ADDENDUM NO. 2

FEBRUARY 28, 2024

Staunton City Public Schools, VA
Shelburne Middle School Additions and Renovations
CRA Project No. 3636

3 ADMIN AREA NEW WORK POWER PLAN - RENOVATION

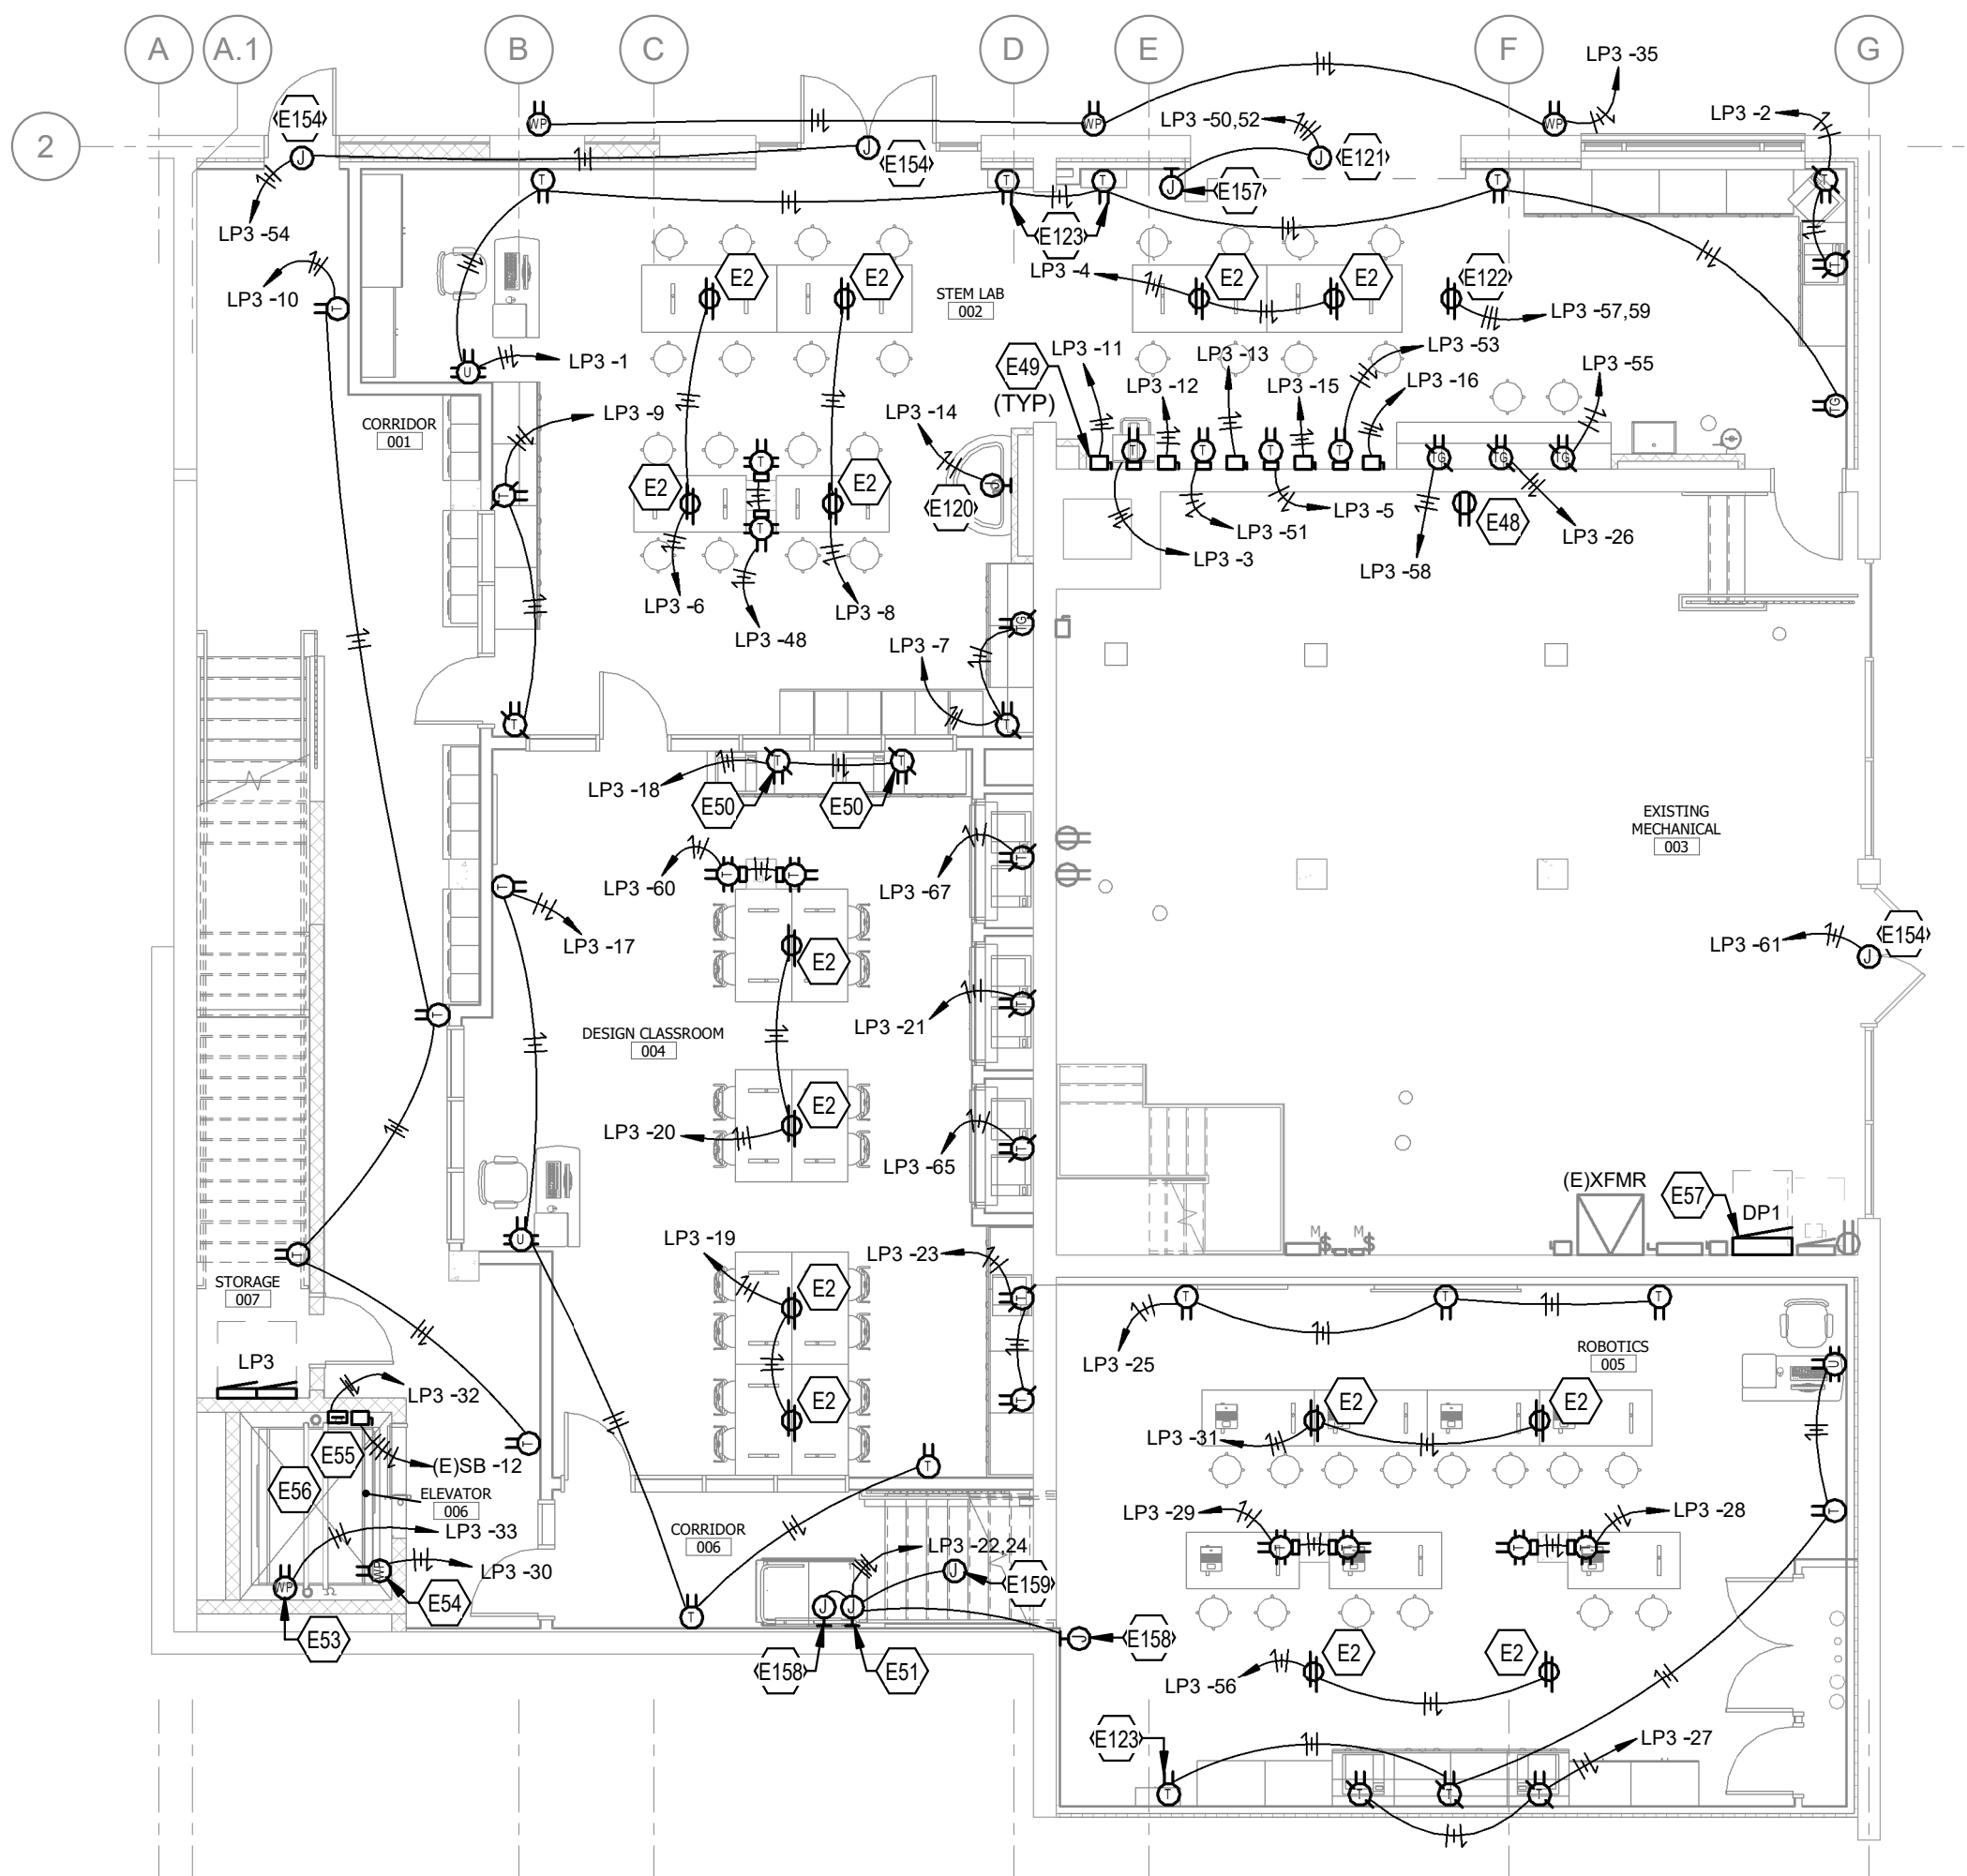
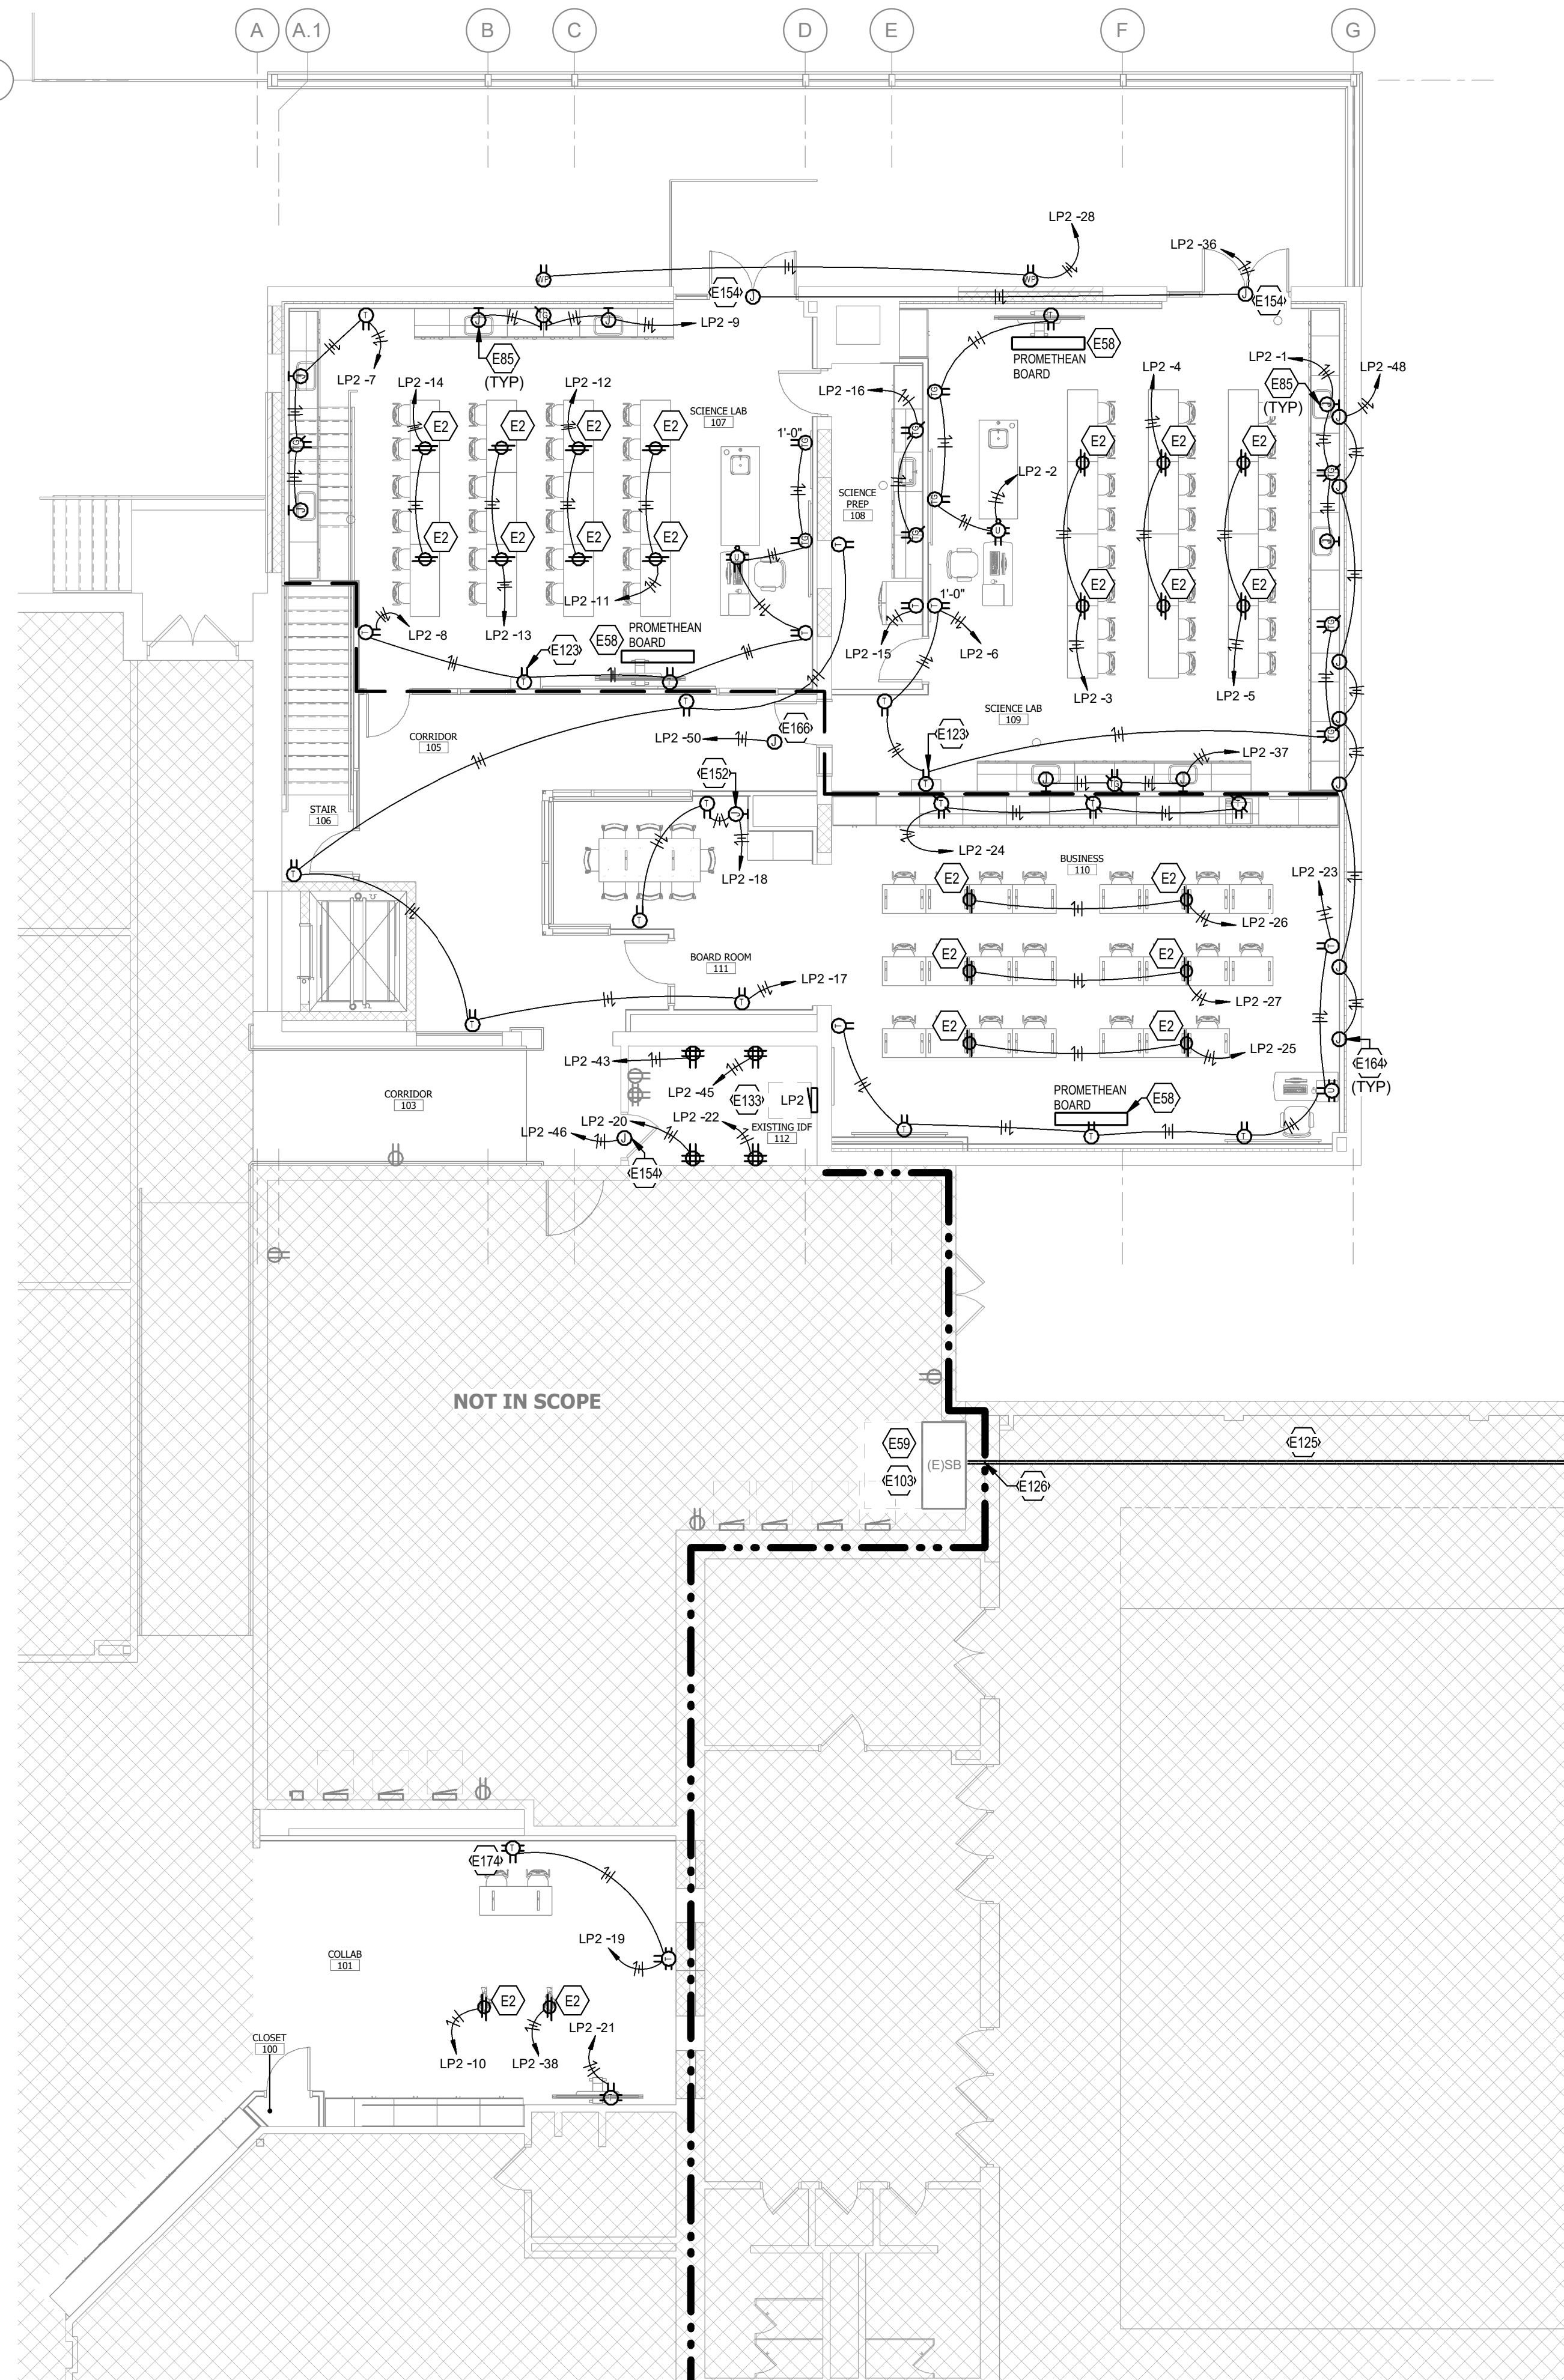
1. **DELETE** this sheet in its entirety and **REPLACE** with the attached sheet.
 - a. **ADD** (1) tamper-resistant duplex receptacle and connect to existing circuit in Admin 141.
 - b. **ADD** keynote E182 calling for wire mold as required in Work Room 145.
